Department of Planning & Community & Economic Development

**TO:** Urban Design Commission

**SUBJECT:** 222 N. Charter Street – Informational Presentation/Concept Presentation regarding a proposal to demolish the site’s existing building, rezone the property from the Traditional Residential – Urban 2 (TR-U2) District to the Planned Development (PD) District, and construct a 12-story student housing building with 43 dwelling units (96 bedrooms) on a property located at 222 N. Charter Street, 8th Ald. Dist.

*Image 1: Diagram of Column Spacing and Arcade Depth*

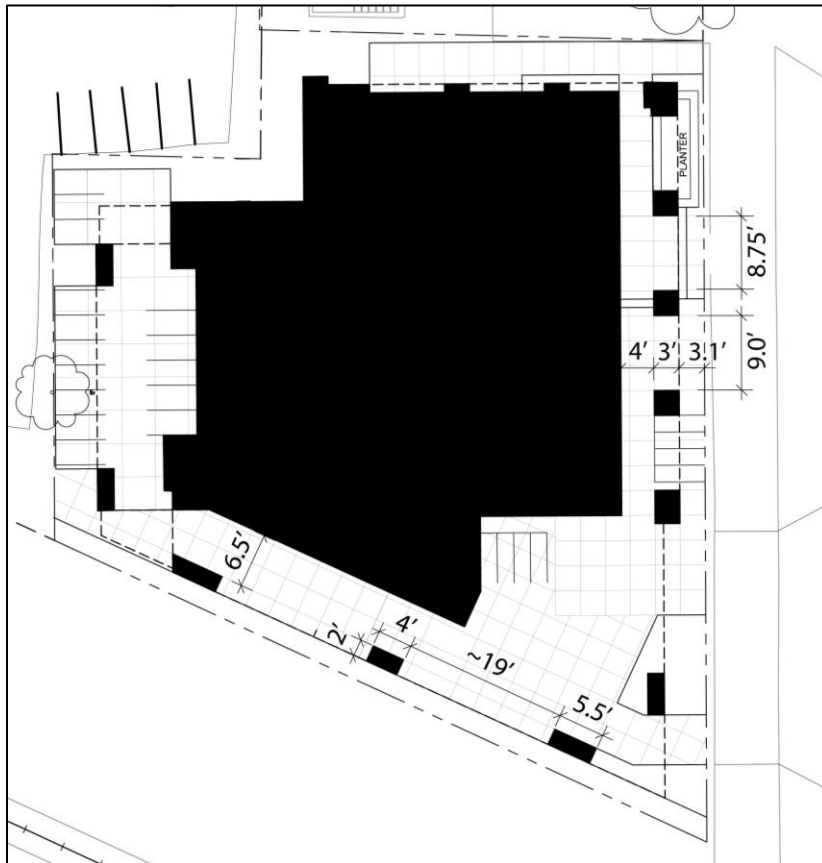
While acknowledging that some improvements have been made from the August 16, 2017 iteration, Planning Division staff's concerns about some of the proposals' inconsistencies with the [Regent Street – South Campus Neighborhood Plan](#) remain. Only at the ground level of the N. Charter Street and the future bike corridor (i.e. southern) façades does the design comply with the neighborhood plan building setback recommendations. However, while staff believe the building's southern arcade has an open feeling – due to the wide column spacing, the thinner (2-foot) column depth, the lack of obstructions in between the columns, and the larger (~6.5-foot) space between the back of the columns and the façade – Staff do not believe the arcade along the N. Charter Street façade has the same feeling. Staff believe this is due to the shallower (4 foot) distance from back of column to the façade, the greater (3-foot) column depth, their closer spacing, and the landscaping and bicycle parking stalls in between the columns. (Please see Image 1 below). Staff believe that in order to make the N. Charter Street façade feel more open, the depth profile of these columns should to be reduced and their spacing increased. This means either eliminating the 3-story, brick-veneer treatment (which staff is not in favor of as we feel this base treatment helps ground the building), or the applicant needs to actually step back the façade above the third story. Either way, the depth of the columns would be reduced to 2 feet.

Additionally, instead of creating an inhabitable arcade along N. Charter Street, Staff believe the ground floor façade here needs to be set back further, with a preference for at least 6 feet. This would create a space that is actually usable by the tenants.

Furthermore, the current design does not comply with any of the recommended neighborhood plan setbacks (i.e. a 15-foot setback above the third floor for the N. Charter Street façade and a ten-foot setback above the third floor with an additional 10-foot setback above the eighth story for the southern façade). The design includes only a 1-foot setback above the third story along the N. Charter Street and northern façades. It should be noted however that this setback was not included in the August 16 design iteration but rather was created subsequently as a result of the applicant adding the 3-story, brick-veneer base treatment (which projects one foot out from the rest of the façade). The net result is that the position of the upper floors of the N. Charter Street façade have not moved back any.
